Contract Change Order # 1

Project Name: <u>Events Park Security Lighting</u>	Project Number: <u>176041</u>
Project Location: <u>Events Park</u>	Date of Application: <u>Tuesday, January 9, 2018</u>
Contractor: <u>Third Generation Electric</u>	Submitted By: <u>Daniel S.</u>

EVENTS PARK SECURITY LIGHTING

ELECTRICAL PLAN

PROFILE SCALE:	DESIGN	DATE	DRAFTED	DATE
HORZ.	CN	3-23-2017	CH	3-23-2017
VERT.	REVIEWED	DATE	APPROVED	DATE
	CN	3-23-2017	CH	3-23-2017
DRAWING NAME:	SHEET	E1	PROJECT NO.	
ELECTRICAL PLAN	OF	3	176041

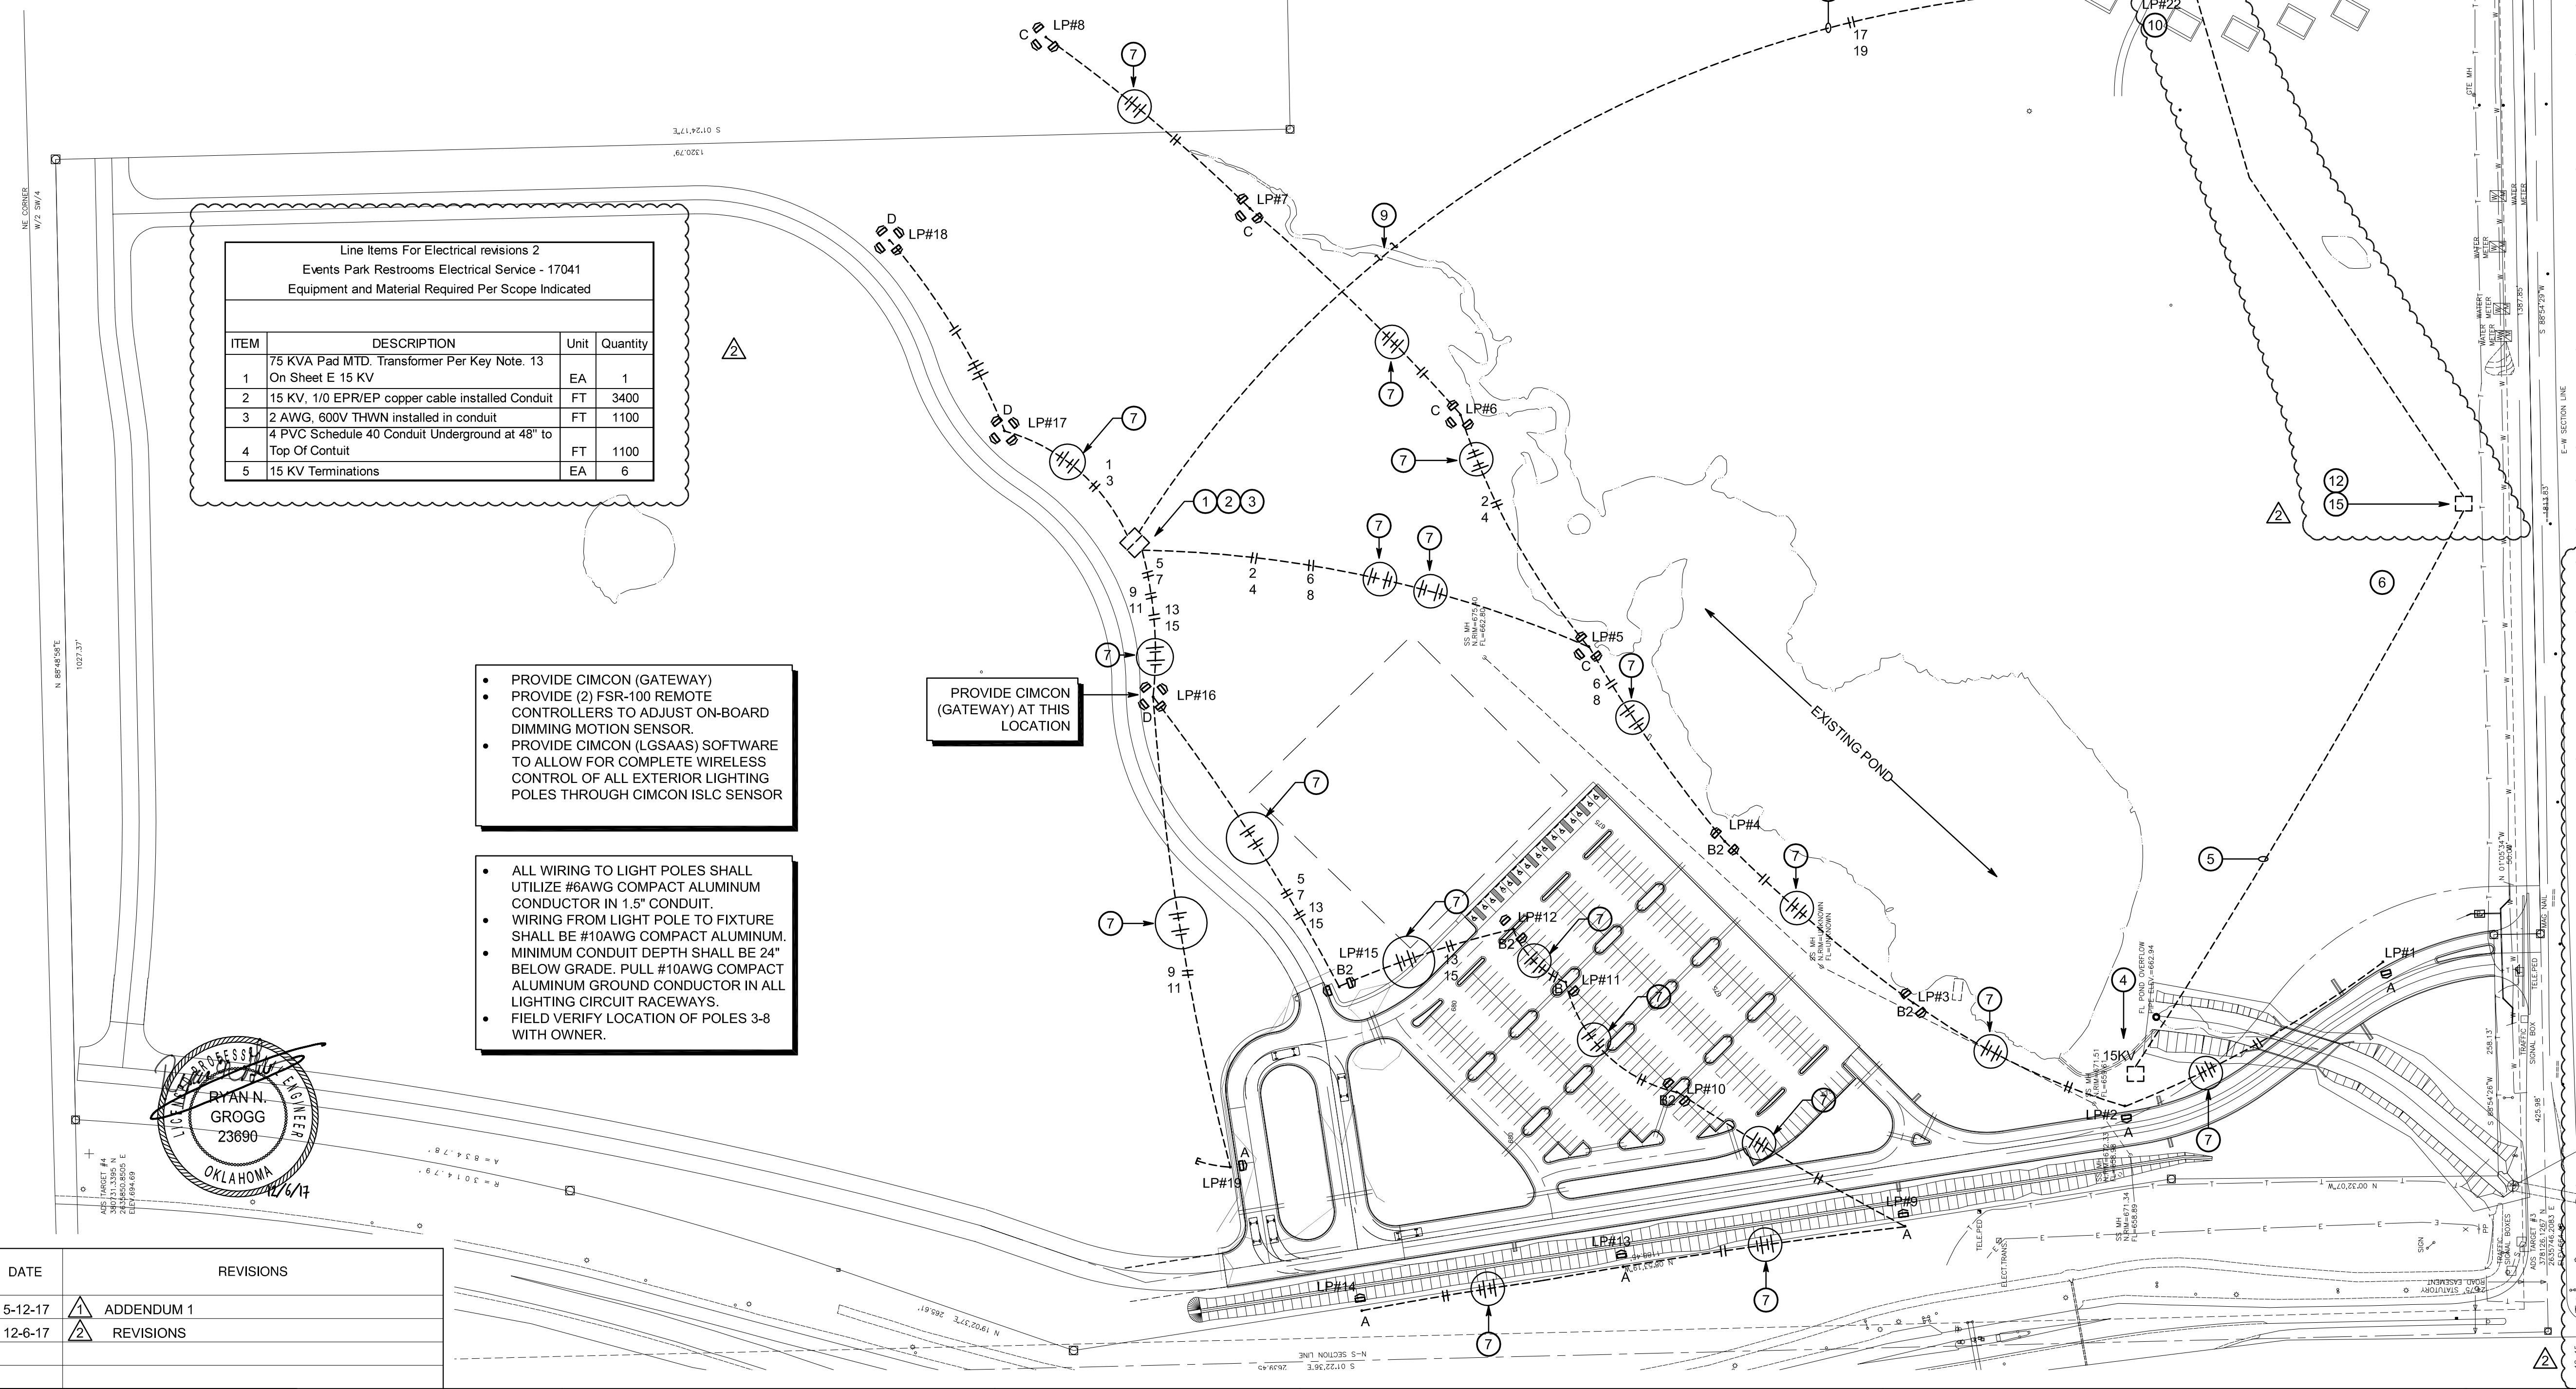
- Due to revisions to the Events Park Restroom project, the 15Kv extension part of the additional alternate associated with this Security Lighting contract will be extended to service the restroom and playground complex. This extension is to include the line extension to the restroom building (1000 LF of service), installation of a 75Kva transformer, and all associated terminations and lines. The installation of
- 1) the 1000 LF of 4" conduit installed in place shall be extended through line item overruns in the base contract. The plans for installation are attached within and are to be incorporated into the contract documents. The costs summarized below are inclusive of all work described above and all applicable markups.

Electrical work per keynote 12,13,14, 15 Sheet E1 Events Park Lighting.

- EXISTING 15KV TAP CABINET. EXTEND 15 KV FEEDER FROM TAP CABINET USING 3#1/0, SHIELDED, 'EPR' INSULATION, EP JACKET COPPER CONDUCTOR, #2AWG THWN GROUND IN 4" PVC CONDUIT & FEED NEW 75KVA PAD MOUNTED TRANSFORMER REF: KEYNOTE 15. MAINTAIN 15KV FEEDER MINIMUM 52" (TO TOP OF CONDUIT) BELOW GRADE. REFER TO INSTALLATION DETAIL.

- NEW PAD MOUNTED 13.2KV/208-120V, 3PH, 4W, DEAD FRONT, LOOP FEED WITH DRY CANISTERS & CURRENT LIMITING FUSES.
TRANSFORMER WITH:
a. COOLING PANELS
b. TANK WITH WELDED COVER

p. L.V. BUSHINGS
q. 1" DRAIN PLUG WITH DRAIN VALVE & SAMPLING DEVICE
r. GROUND PADS PER ANSI
s. REMOVABLE FRONT SILL
 - EXTEND SECONDARY SERVICE, 4#4/0, #4G, 2.5"C FROM TRANSFORMER TO J-BOX ON EXTERIOR WALL & FROM J-BOX TO PANEL INSIDE BUILDING BY MEANS OF UNDER GROUND FEEDER. KEYNOTE IS FOR REFERENCE ONLY. THIS FEEDER IS BEING INSTALLED UNDER A SEPARATE CONTRACT.

- ALL 15 KV TERMINATIONS MUST BE PERFORMED BY TRAINED & CERTIFIED TECH. USE 3M, COLD SHRINK QT-II, 15 KV 5633K OR EQUAL TERMINATION KIT.
